SUBJECT: REQUEST FOR ADDITIONAL INFORMATION REGARDING APPROVAL TO
ADD NUHOMS[®]-32PT DRY STORAGE CANISTER TO THE STANDARDIZED
NUHOMS[®] SYSTEM (TAC NO. L23343)

TRANSNUCLEAR, INC.
DOCKET NO. 72-1004
TAC NO. L23343

REQUEST FOR ADDITIONAL INFORMATION

Figure 1. Illustration of parallel paths $k_{eff-along}$ assumed in TN's ANSYS® model for the basket and associated components

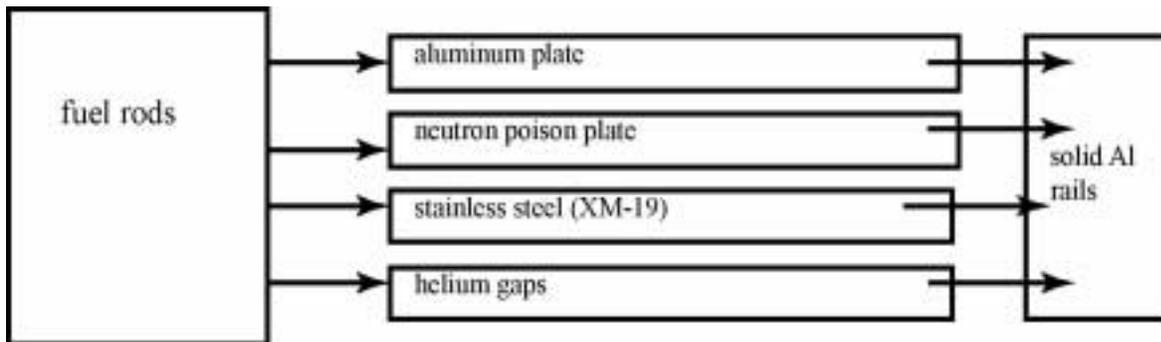
When applied to heat transfer from the fuel elements in the NUHOMS®-32PT canister, the parallel paths are treated as illustrated in Figure 1.

This approach can be used to represent the heat flow path along the layers and along the length of the canister (although in this direction these components do not connect directly to the support rails). However, axial heat transfer is capable of removing only a small part of the heat from the canister. This is by design; the structure of the storage module in which the canister sits requires that the canister design allow the bulk of the heat to be removed through the sides of the canister. This means that most of the heat transfer is in the radial direction.

Figure 2. Conceptual diagram of radial heat flow through the basket region

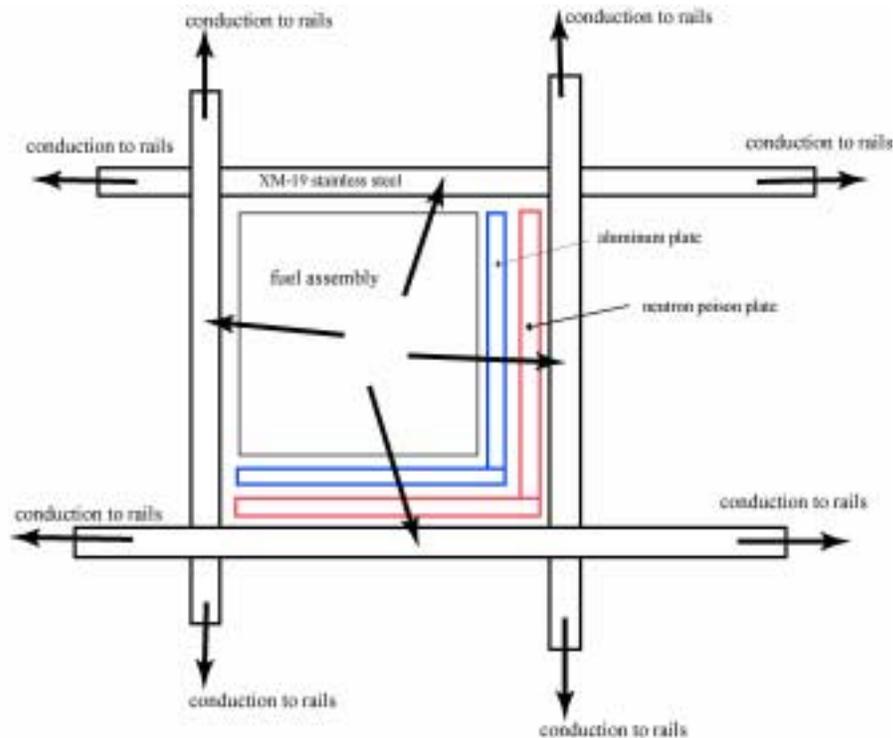
Figure 2 is a conceptual representation of these radial heat transfer paths through the basket. In no case can the heat flow be treated as following a parallel path (along the layers) exclusively, as described by the equation above. The effect of using a $k_{eff-along}$ as defined as in the above equation for radial heat transfer through the basket, results in a significant overestimation of the effective thermal conductivity of the basket structure.

In this case, for the direction passing through the right or lower wall of the “cell” depicted in Figure 2, the applied effective thermal conductivity ($k_{eff-along}$) works out to be a little more than four times that which should have been applied ($k_{eff-through}$) as illustrated by the following calculation.

Inserting appropriate values for these thermal conductivities and using the specified dimensions of the various components yields a value for $k_{eff-along}$ that works out to be approximately 4.3 to 4.7 times larger than $k_{eff-through}$.

A value of $k_{eff-along}$ was applied in all directions in the ANSYS® model supplied by TN, to define the effective thermal conductivity in the bodies representing the basket region. The different materials in the basket region were not modeled in ANSYS® with separate material orientation (orthotropic) and property definitions for aluminum, neutron poison, stainless steel, or gaps. Instead, the entire structure of the basket was represented as a 'uniform' material in which all bodies had the same effective thermal conductivity, calculated in the manner described above for $k_{eff-along}$. Hence, the same value of $k_{eff-along}$ was applied in both the "along" and "through" directions. This is an incorrect approach as heat transfer must pass serially through the aluminum and neutron plates and associated gas gaps and then into and through the stainless steel to reach the support rails.

1. Revise the thermal model of the NUHOMS®-32PT DSC to take into account the orthotropic nature of the basket materials, including the helium, aluminum, and neutron poison materials. The thermal conductivity of the basket materials will not be the same across the aluminum and neutron poison plates (serial path) as it would be along the aluminum and neutron poison plates (parallel path).
2. If, after the revision to the thermal model as described above is complete, fuel cladding temperatures are above the applicable limits, provide an alternative path for certification of the NUHOMS®-32PT DSC.
